# UNITED STATES PATENT AND TRADEMARK OFFICE

APPLICATION NO.	FILING DATE	FIRST NAMED INVENTOR	ATTORNEY DOCKET NO.	CONFIRMATION NO.
10/694,021	10/28/2003	Henry Rosenthal	116364	3701

# Office Action Summary

3. The drawings were received on November 3, 2004. These drawings are unaccepted by the Examiner because the corrected Fig. 1 and new Figs. 5-8 introduce new matter for the reasons, among other things, listed below:

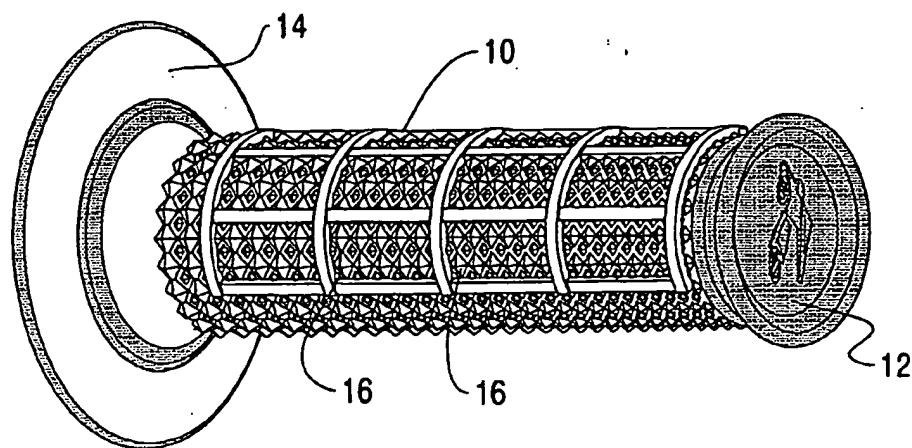
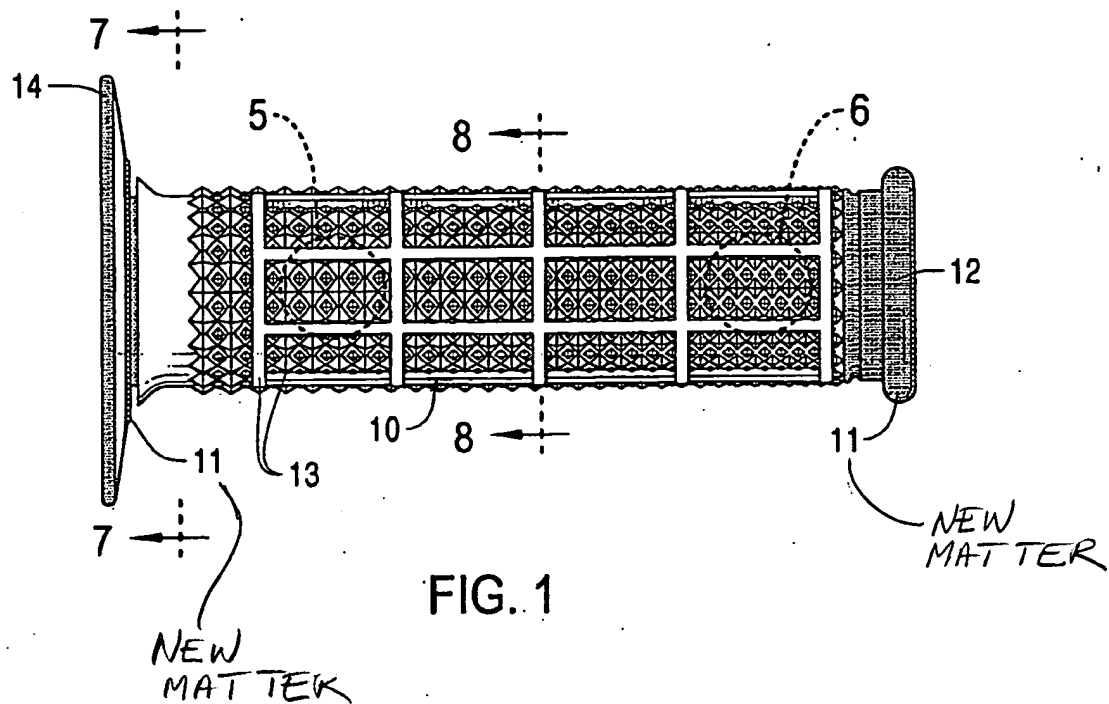
(a) the new referential numeral 11 that indicates the inner layer of the body 10 as now shown in corrected Fig. 1 introduces new matter. See Attachment. Applicant's original disclosure does not disclose that the inner layer is extended to and contacted with the flange 14. In other words, the concept that the inner layer is extended to and contacted with the flange 14 is not conveyed in the original disclosure, *i.e.*, new matter. *In re Anderson*, 176 USPQ 331 (CCPA 1973);

(b) Applicant's original disclosure does not disclose that the inner layer, the flange 14, and the end wall 12 are formed as one piece as now shown in corrected Fig. 1. In fact, the description "[a] firmer less flexible grade is used to form a base or inner layer of the body 10,

as well as the end wall 12 and the flange 14” on page 4 of the original specification implies that the inner layer, the end wall 12, and the flange 14 are formed as separate pieces and connected together. In other words, the concept that the inner layer, the flange 14, and the end wall 12 are formed as one piece is not conveyed in the original disclosure, *i.e.*, new matter. *In re Anderson*, 176 USPQ 331 (CCPA 1973);

6. The amendment filed November 3, 2004 is objected to under 35 U.S.C. 132 because it introduces new matter into the disclosure. 35 U.S.C. 132 states that no amendment shall introduce new matter into the disclosure of the invention. The added material which is not supported by the original disclosure is as follows: the description of new Figs. 5-8 and the new referential numerals, such as, "11" to indicate the inner layer in corrected Fig. 1.

The Examiner respectfully submits that the original disclosure does not describe, among other things, that the inner layer is extended to and contacted with the flange 14. In other words, the concept that the inner layer is extended to and contacted with the flange 14 is not conveyed in the original disclosure, *i.e.*, new matter. *In re Anderson, supra*. See other new matter set forth in the disapproval for drawing correction in paragraph 3 above. Applicant is required to cancel the new matter in the reply to this Office Action.

FIG. 5

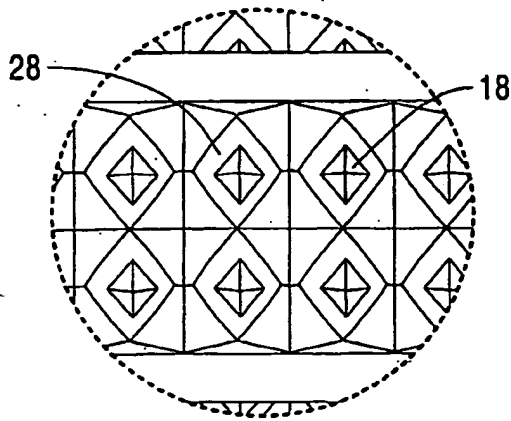
Applicant states “[s]upport for new Figs. 5 and 6 is provided in original Figs. 1-4, page 2, lines 15-18; page 2, lines 1-2; and page 4, lines 14-19. Support for new Figs. 7 and 8 is provided in original Figs. 1-4; page 3, lines 4-9; page 4, lines 7-12 and original claims 4-19. Thus, Figs. 5-8 do not contain new matter.”

Contrary to Applicant's remarks, the quoted portion in the original disclosure does not provide support, e.g., the thickness of the inner layer relative to the thickness of the outer layer as now shown in new Figs. 7 and 8. Therefore, new Figs. 5-8 contain new matter as explained in paragraph 3 above.

FIG. 7

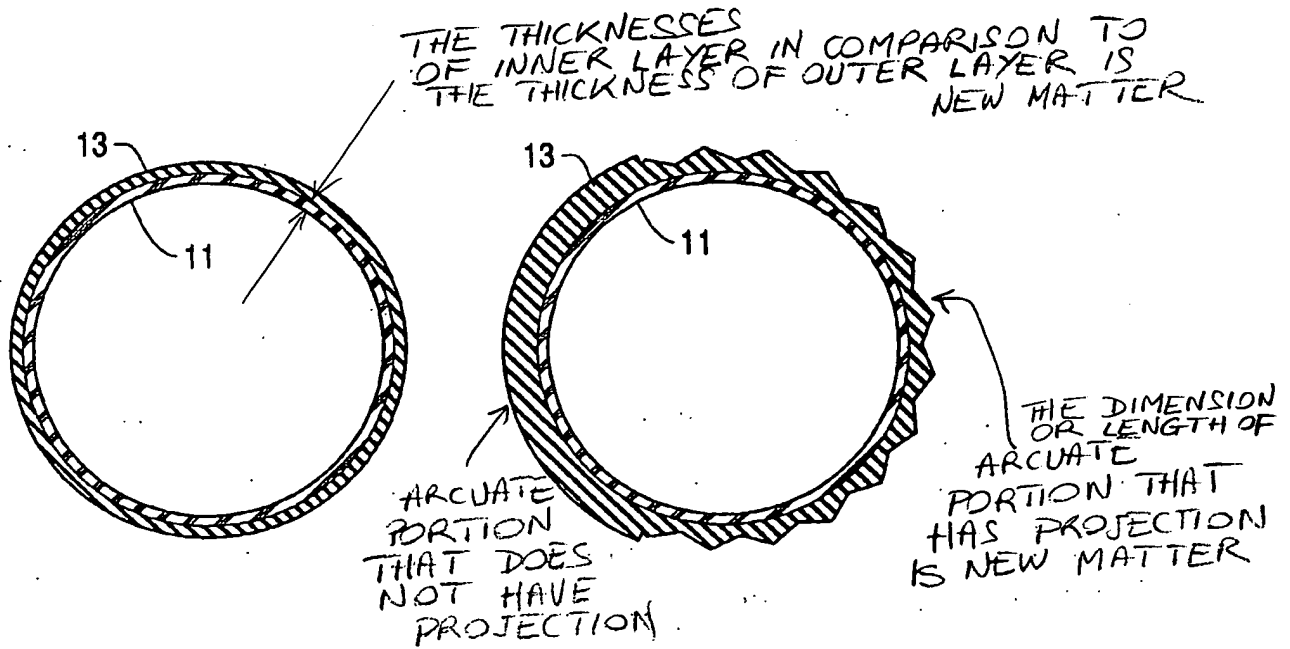
(c) the thickness of the inner layer (Att.) in comparison to the thickness of the outer layer as now shown in new Figs. 7 and 8 introduces new matter. The original disclosure does not describe the thickness of the inner layer in comparison to the thickness of the outer layer. Therefore, the original disclosure implies that the thickness of the inner layer may be equal, greater, or less than the thickness of the outer layer. The specific showing of the thickness of the inner layer relative to the thickness of the outer layer within a full spectrum of possible thicknesses is considered under the present disclosure to be new matter. *Cf.*, *In re Smith*, 173 USPQ 679 (CCPA 1972) and *Ex parte George*, 230 USPQ 575, 578 (BPAI 1986); and

(d) the arcuate portion of the outer surface of the outer layer that has projections as now shown in new Fig. 8 introduces new matter. The original disclosure does not describe that the arcuate portion that has projections is substantially greater than the other arcuate portion that does not have projection as now shown in Fig. 8. The original disclosure implies that the peripheral length or dimension of the arcuate portion that has projections may be equal, greater, or less than the peripheral length or dimension of the arcuate portion that does not have projection. The specific showing of the peripheral length or dimension of the arcuate portion that has projections relative to the peripheral length or dimension of the arcuate portion that does

Applicant contends that the amended drawings including new Figs. 7 and 8 show the inner and outer layers. However, the corrected drawings introduce new matter as explained above. *In re Smith* and *Ex parte George, supra*. To the extent that Applicants have complied with the Examiner's objection to the original drawings by corrected Fig. 1 and adding new Figs. 5-8 by submission of the amendment, the Examiner respectfully submits that the claimed feature in claims 4-9 required under 37 CFR 1.83 should have been shown *on the filing date*. The Applicant is respectfully advised that Section 608.01(h) of MPEP states:
